## CCPS RFP#25-04 – NORTH EAST MIDDLE/HIGH SCHOOL REPLACEMENT PROJECT

### ADDENDUM #7

**This addendum is to provide the pre-bid agenda and attendance list and issued revisions to the contract documents as noted below.** Proposers and related parties will be responsible for reading and understanding all documents, the scope of work, addenda and all related solicitation documents issued. These documents will become attached to and part of the solicitation and award of bid contract.

1. **ASIs 01 and 02**
2. **PR 01**
3. **CLOSED RFIs 001- 0027, 029-031, 034. (open RFIs are excluded)**

A7 TYP. FOUNDATION DETAIL W. CMU BACK-UP  
11'-2" = 1'-0"

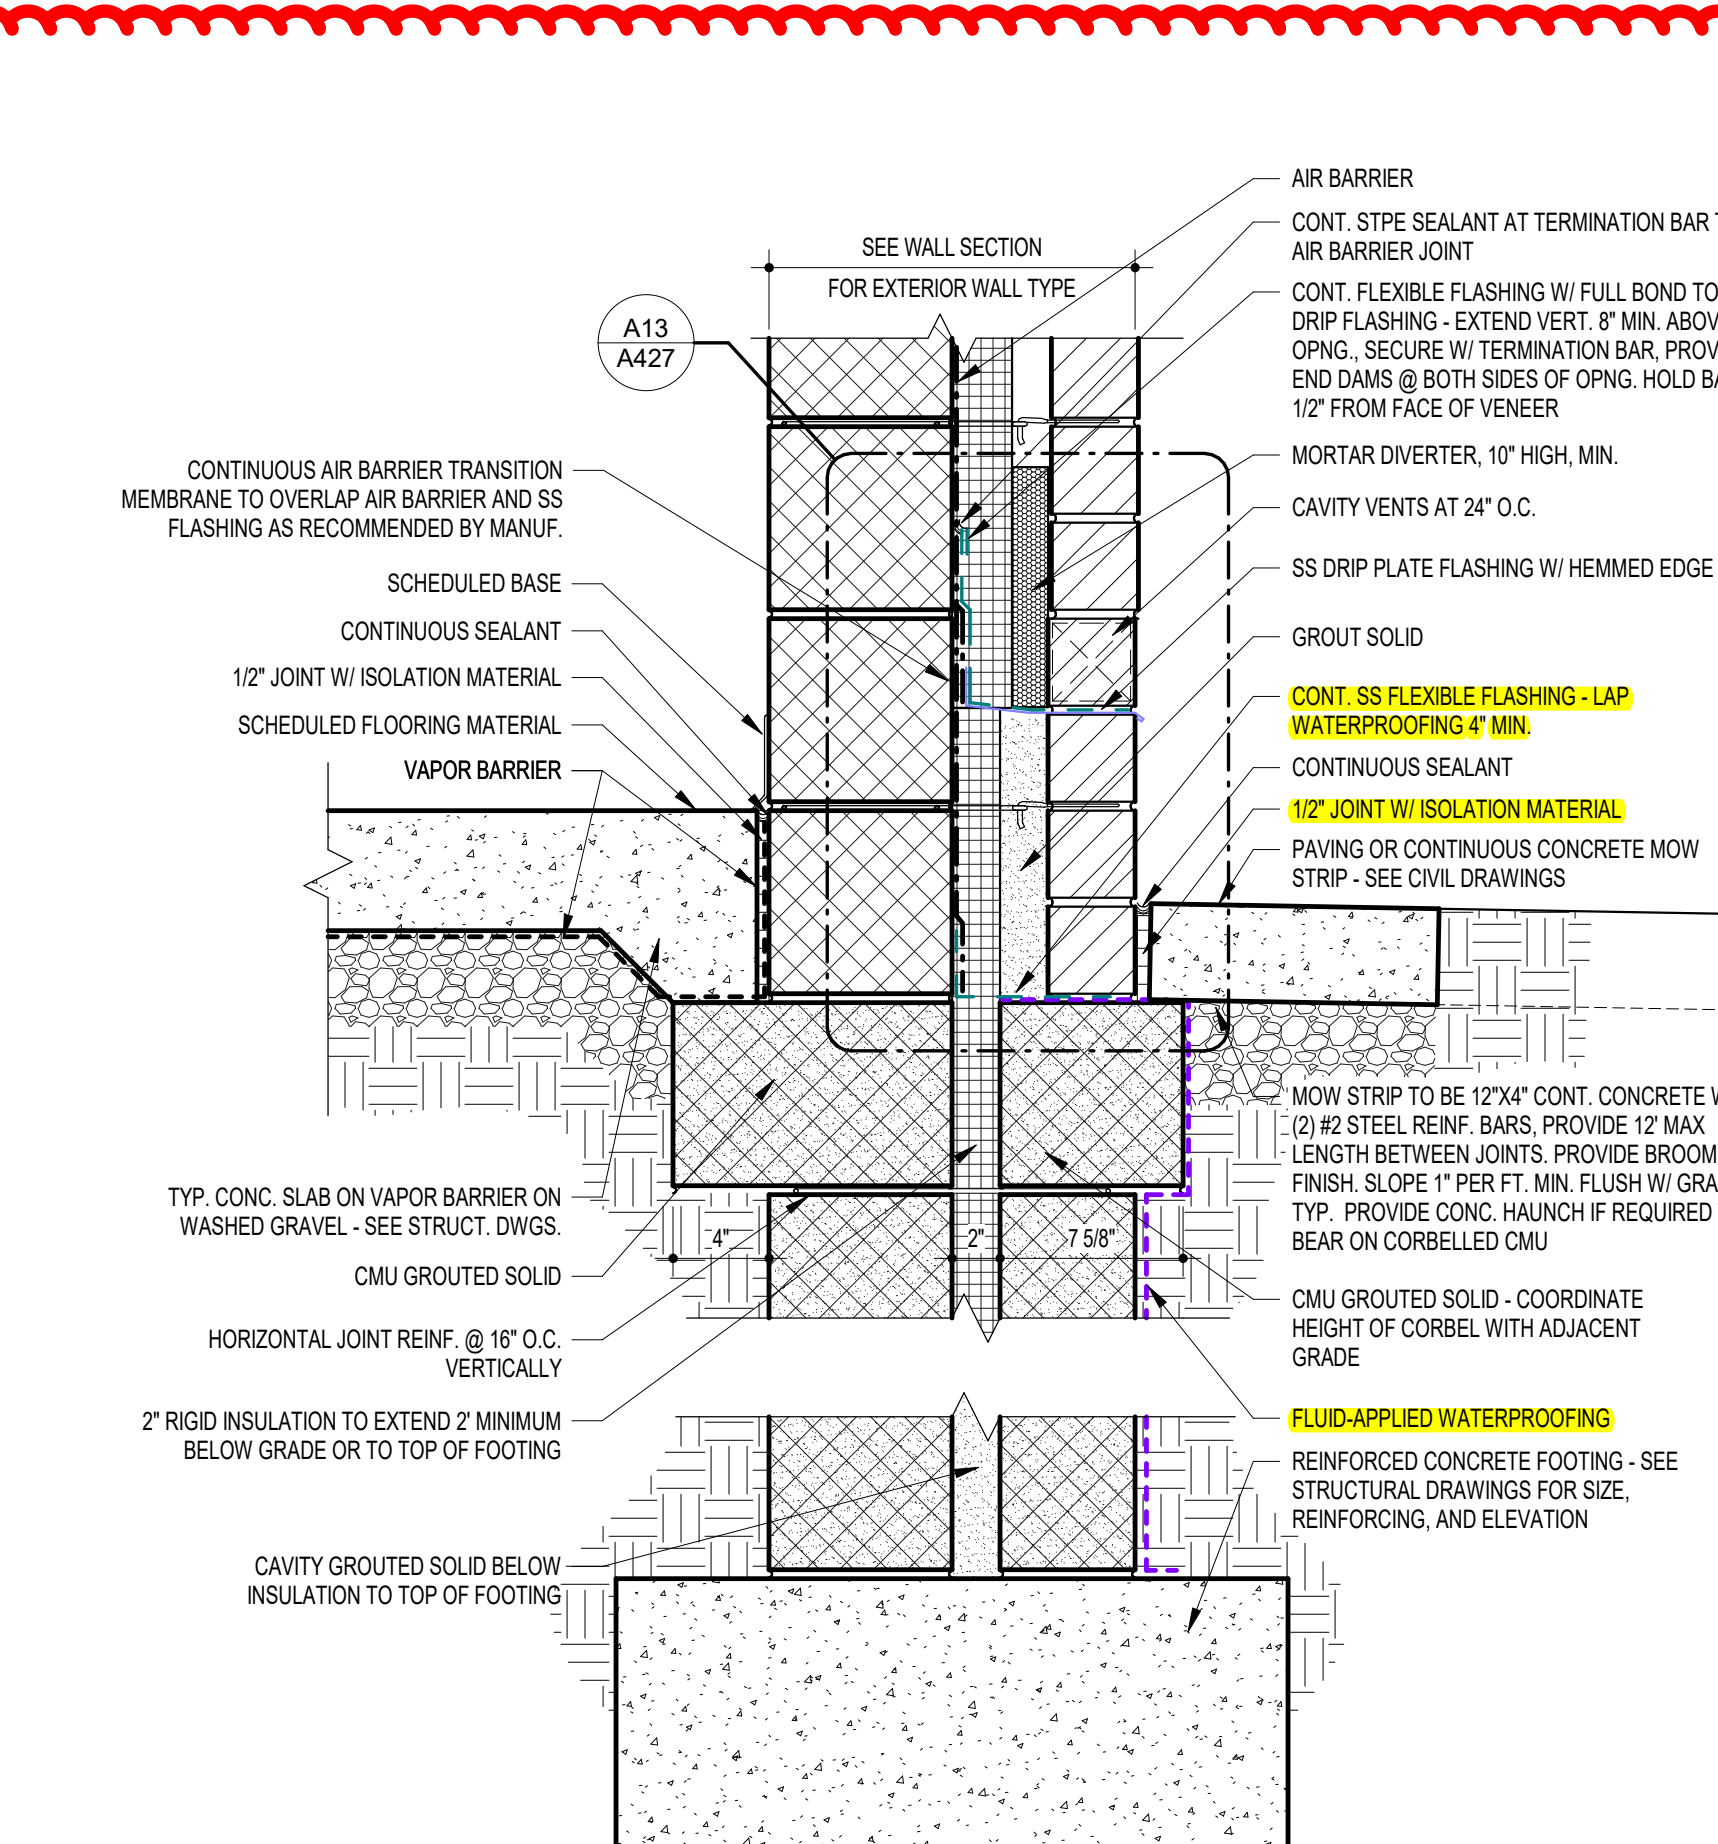
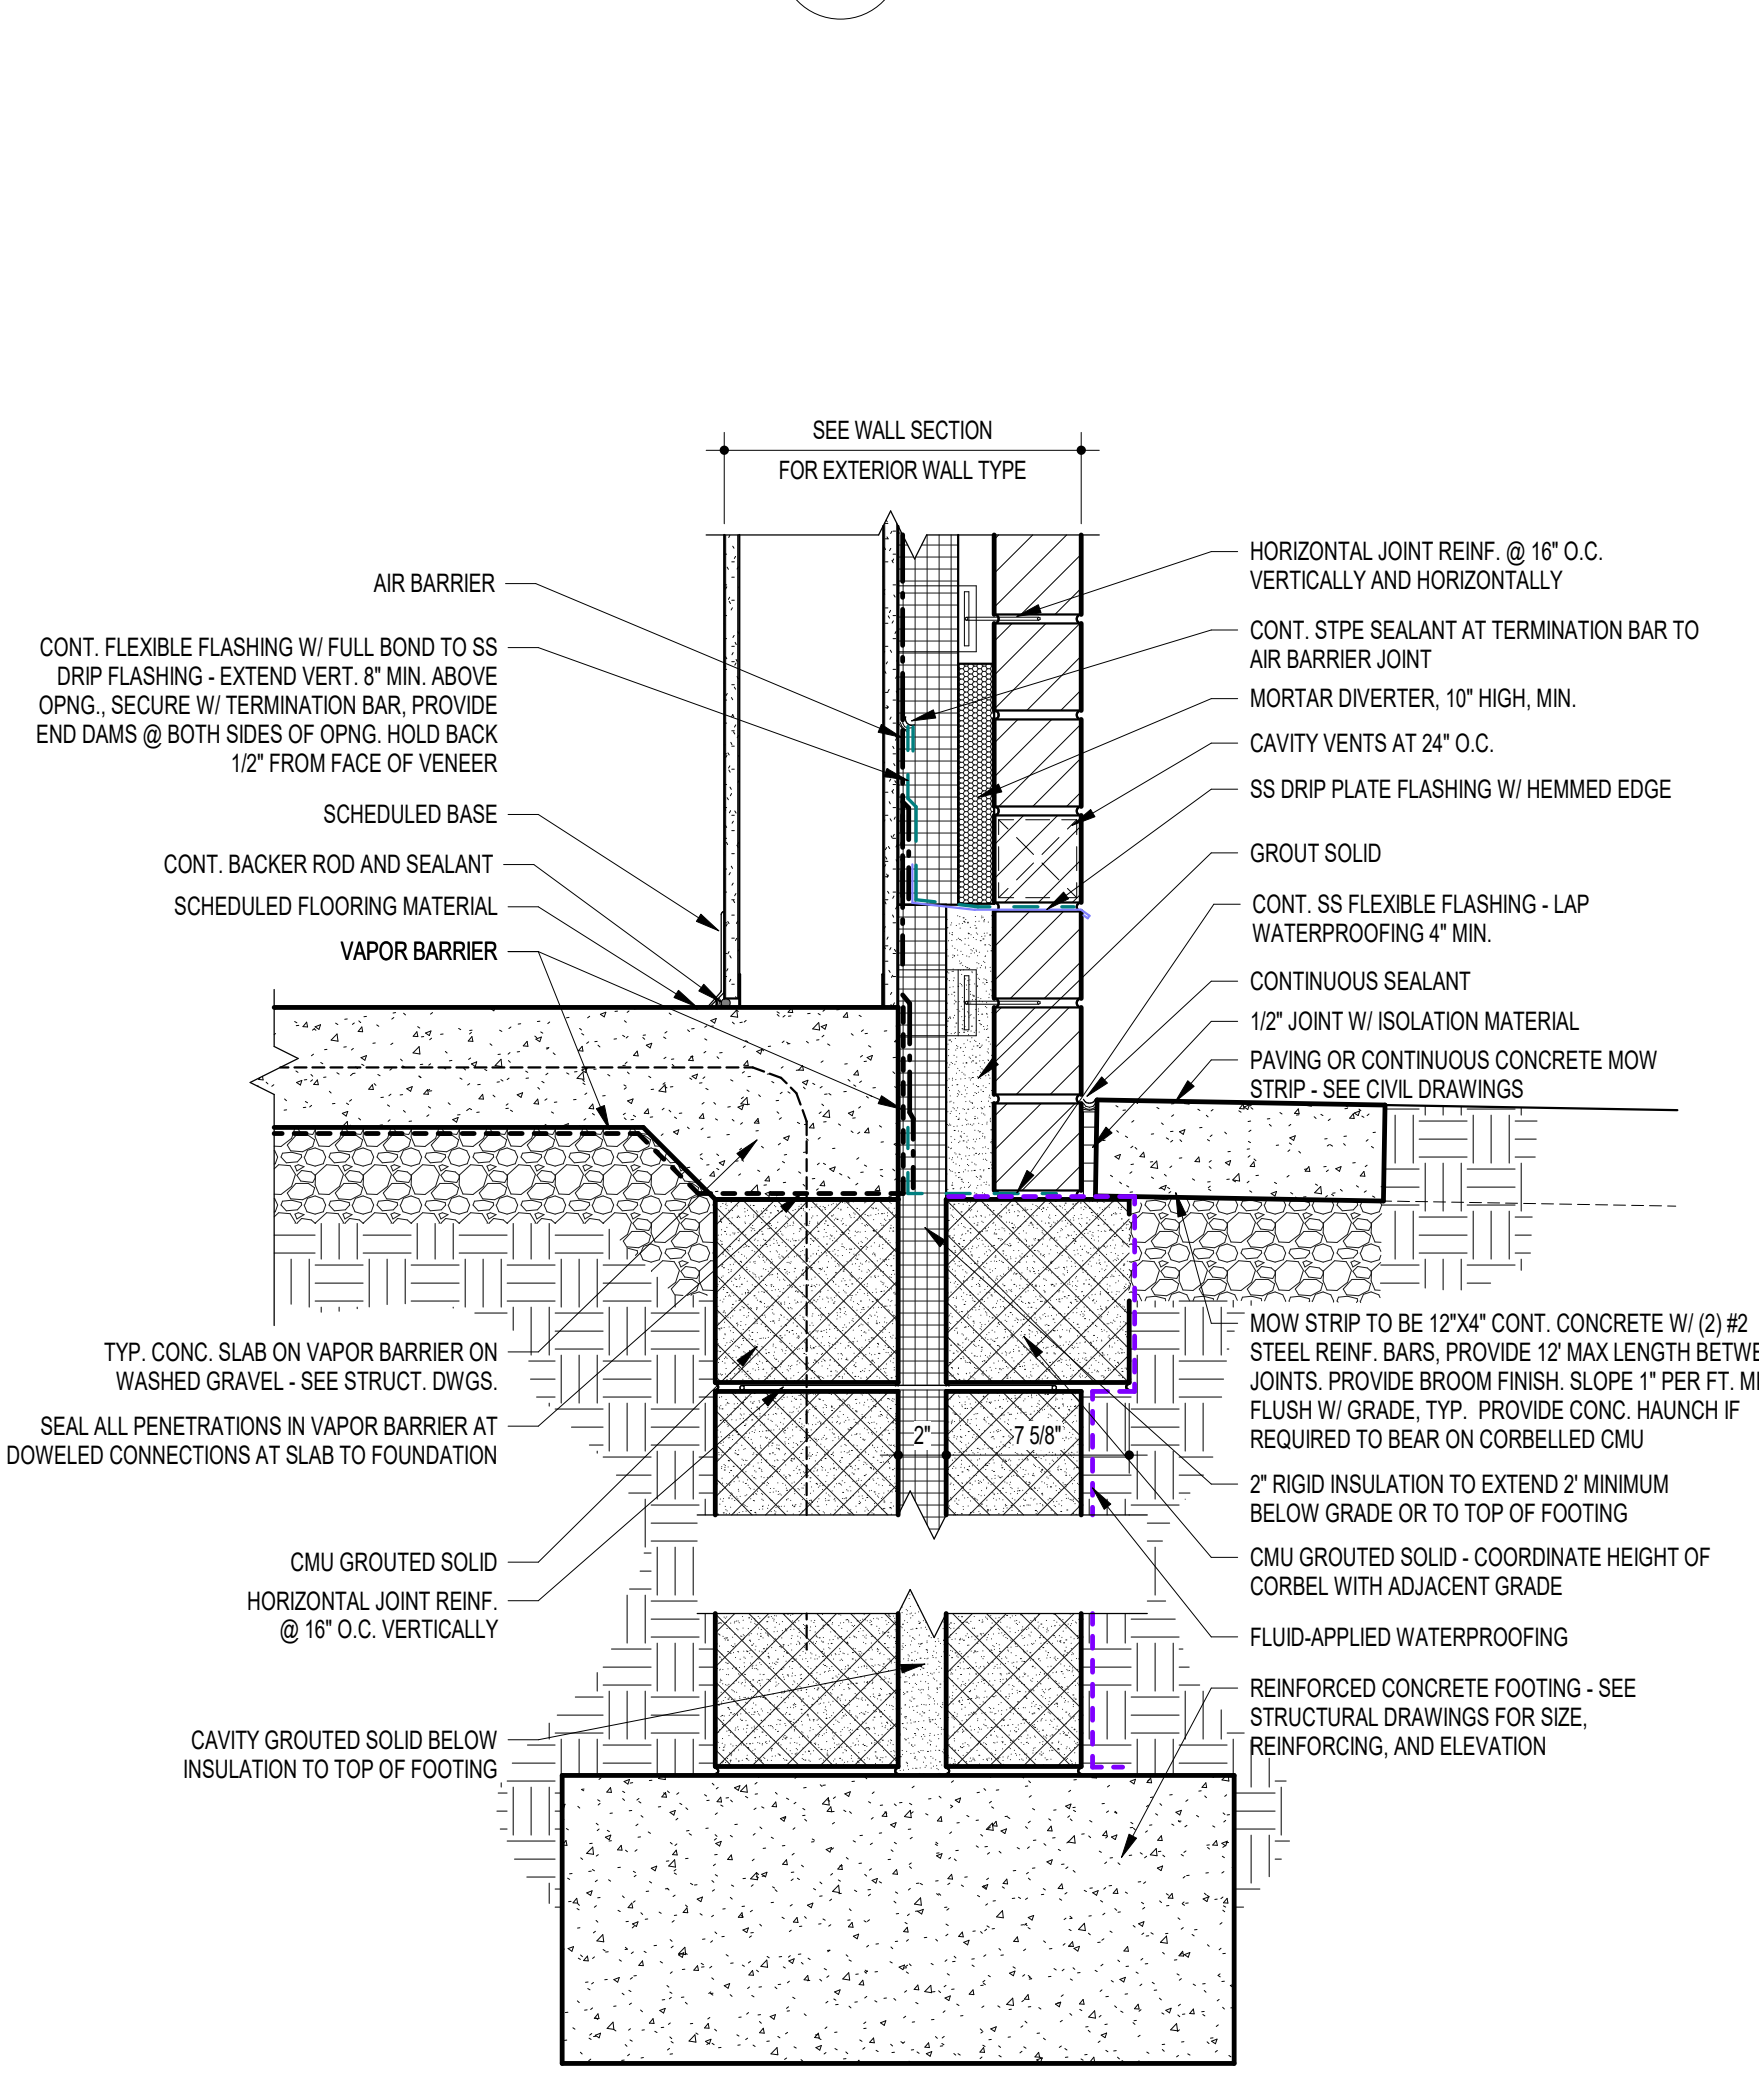
Patrick, 07 11 13 Section 3.3 B calls for the dampproofing to extend over top of footing and down a minimum of 6 inches, whereas Detail A7/A427 shows the dampproofing terminating at the top of footing. Please advise whether the dampproofing should be applied per the detail or the specification and please revise the detail/specification accordingly.	<b>Joshua Postadan</b>	Jul 8, 2024, 2:37 PM EDT
<b>Joshua Postadan</b> changed the status from  <b>Open</b> Answered to  <b>Closed</b> <b>Official response:</b> Patrick Byrne (Grimm and Parker): See attached RFI response. set Ball in court to <b>Glenn Feldstein</b> (George Moehrle Masonry)	<b>Joshua Postadan</b>	Jul 8, 2024, 9:57 AM EDT

Received from Grimm + Parker on 7/2/24: "G+P Response: Install the waterproofing as shown on the detail A7/A427 on the outer wythe of the CMU wall. Install damp proofing as described in Part 3 of the damp proofing specification section 071113, 3.3B. Patrick Byrne 7.2.24" Please review the response to RFI #009. Provide notification of any cost implications immediately. If a proposal has cost impacts, please request an RFQ from HESS. Send a proposal no later than the close of business within 7 days of receipt of this RFI response. HESS will consider this as a no cost change and close this issue should a proposal not be received by this date. A lack of response for any credit items will prompt HESS Construction to assign a cost value that will be deducted from your contract sum. Note: The RFQ is simply an administrative tracking tool, and in no way represents that additional work, cost or time is acknowledged, authorized, directed, or approved. Thank you,

Detail A7/A427 is a detail for the foundation waterproofing system. The referenced specification section in the RFI is for damp-proofing. Please be aware that these are different systems.
